## Environmental Planning Commission

### Staff Report

**Agenda Item Number: 1**  
**Project #: PR-2021-005339**  
**Case #: SI-2021-00817**  
**Hearing Date: July 15, 2021**

<b>Agent</b>	Consensus Planning
<b>Applicant</b>	Lubricar Properties II, LLC
<b>Request</b>	<b>Site Plan-EPC, Major Amendment</b>
<b>Legal Description</b>	Tract 3-C-1, Plat of Tracts 3C-1 and 3C-2, Black Ranch
<b>Location</b>	Between Valley View Pl. NW and Irving Blvd. NW (9386 Coors Blvd NW)
<b>Size</b>	Approximately 0.57 acre
<b>Zoning</b>	MX-L

**3-6(D)(5) Structure Height**

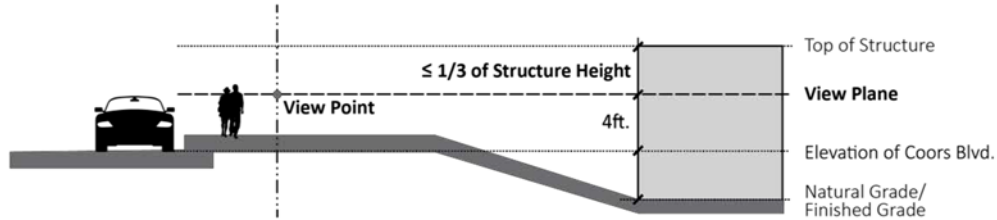
3-6(D)(5)(a) No more than 1/3 of the height of structures (including building parapets, mechanical equipment and associated screening, walls, and fences) shall be allowed to penetrate above the view plane as shown in the diagram below.

*Because the finished grade is within 10' of the elevation of Coors Blvd, this property does not need to comply with the 2/3 vs 1/3 building height requirement shown in the illustration above, rather, it is allowed to be 20 feet for uses other than low-density residential, per Subsection 3-6(D)(5)(b).*

*The addition of the service bays will have a maximum height at the top of the parapet of 16-8', well within the allowable 20' building height for non-residential buildings that are within 10' of the elevation of Coors Boulevard (within the Coors Boulevard VPO-2).*

#### 3-6(D)(6) – Structure Bulk

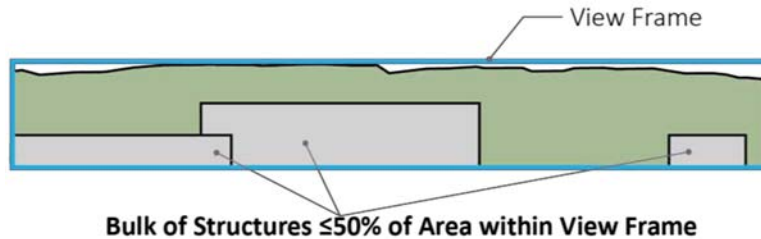
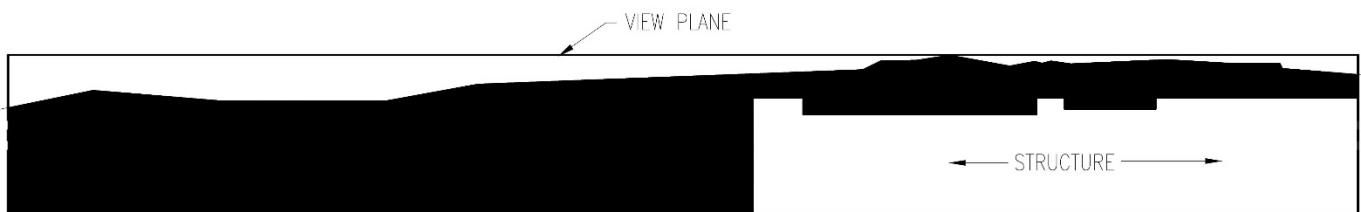
Not more than 50 percent of the area within any view frame for a property shall be obscured by the bulk of the structure(s) (including walls and fences) placed on the property. (See figure below).

*Massing/views are blocked by adjacent development.*
